From: [REDACTED]
Sent: 03 July 2025 20:51
To: Morgan Offshore Wind Project
Subject: Application by Morgan Offshore Wind Limited for an Order granting Development Consent for the proposed Morgan Offshore Wind Project: Generation Assets (PINS ref. EN010136) - Response to Secretary of State Consultation 1 (Lett... [ES-CLOUD_UK.FID12927434]
Attachments: EN020032-001244-1 - BAE Systems - Deadline 1 Submissions.pdf; EN020032-001351 - BAE Systems - Deadline 2 Submissions.pdf; EN010137-002285 - BAE Systems - 23 June 2025.pdf; EN010137-002278 - BAE Systems - 12 June 2025.pdf

We write on behalf of BAE Systems Marine Limited and BAE Systems (Operations) Limited (together, "BAE Systems") in response to the Secretary of State's request for information dated 19 June 2025 – in particular, points 10, 11 and 12 – whereby an update is sought in relation to the post-consent commercial agreement/s to be entered into, together with agreement of the requirement wording concerning Air Traffic Services ("ATS") at Walney and Warton Aerodromes (Requirements 7 and 5 respectively) and the Primary Surveillance Radar at Warton Aerodrome ("the PSR") (Requirement 6).

Applicant's Response to Rule 17 Letter

Figure 4-2: Ben My Chree Transits during 2022 between Heysham and Douglas next to West of Duddon Sands.

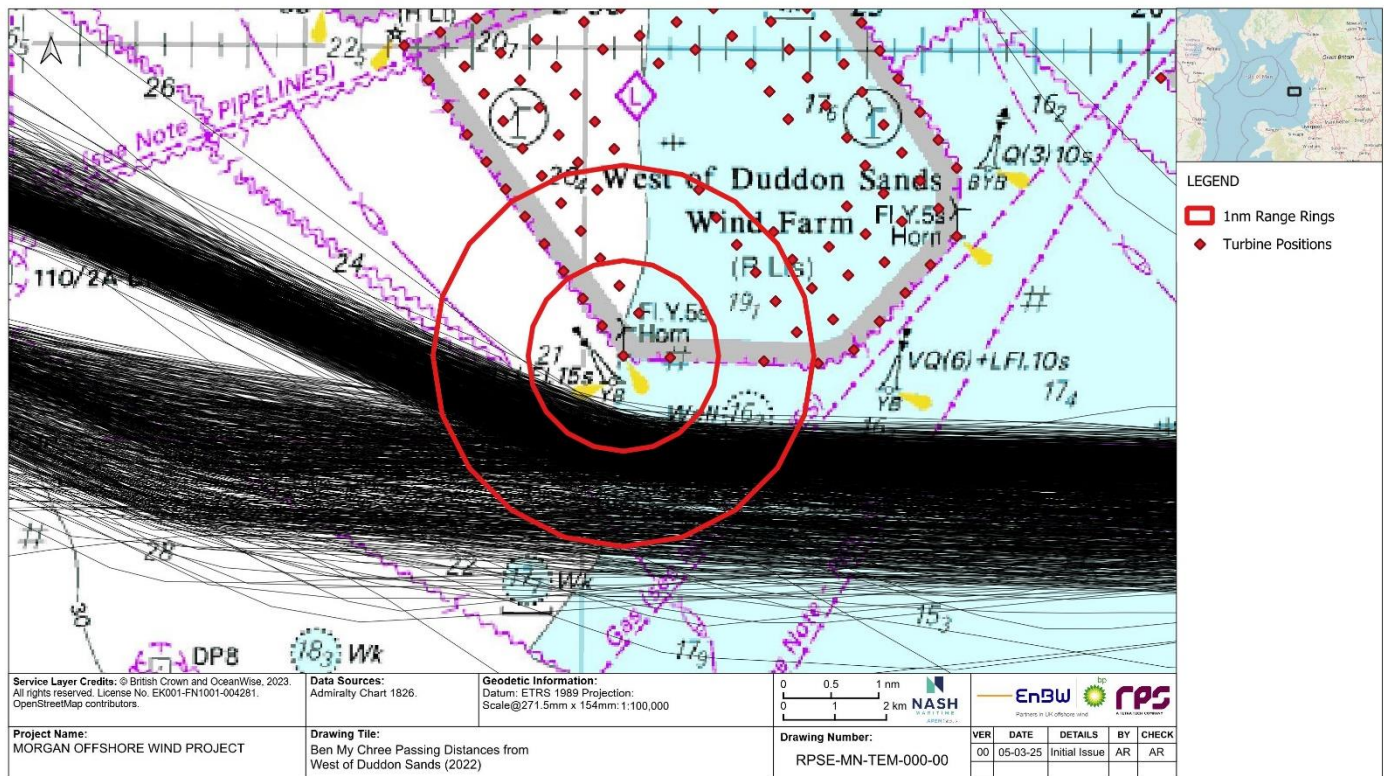
- The Applicant also notes that 2 nm passing distance from the offshore wind farms is inconsistent with typical operational behaviour. For example, more than 80% of all transits of the Ben My Chree during 2022 between Heysham and Douglas passed within 1.5 nm of the most south-westerly turbine of West of Duddon Sands, and 52% passing within 1 nm (Figure 4.2).

Figure 5-1 Exact measurements from respective boundary set backs

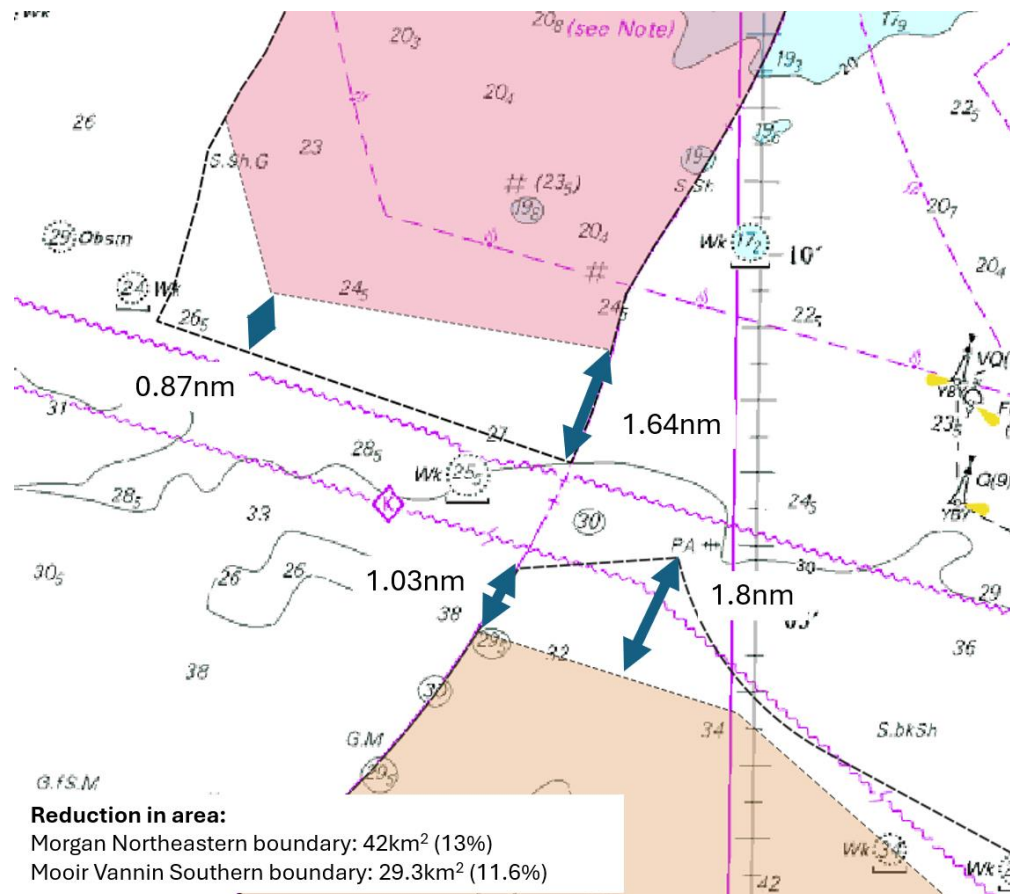
- 5.1.2.6 MVOWFL in its Deadline 5 submission (REP5-075) included comment on the design refinement for each of the Morgan Generation Assets and the Mooir Vannin Offshore Wind Farm to support a submission that there had been a greater reduction in the developable area of the Mooir Vannin Offshore Wind Farm. The information included in MVOWFL's submission does not present the full picture, which the Applicant considers it important to clarify as a point of fact, and has detailed this in Table 5.1 and Figure 5-1 below. The Applicant reduced a greater proportion of array area directly relevant to the gap between the Morgan Generation Assets and the Mooir Vannin Offshore Wind Farm, than MVOWFL presented in their Deadline 5 submission (REP5-075). Further the Applicant has also collectively mitigated for a quarter of the total developable area (25-26%) and any further reduction would lead to considerable capacity loss. The current boundary concessions for both the Applicant and MVOWFL have proven to be ALARP and there should be no further requirement for any increased separation.
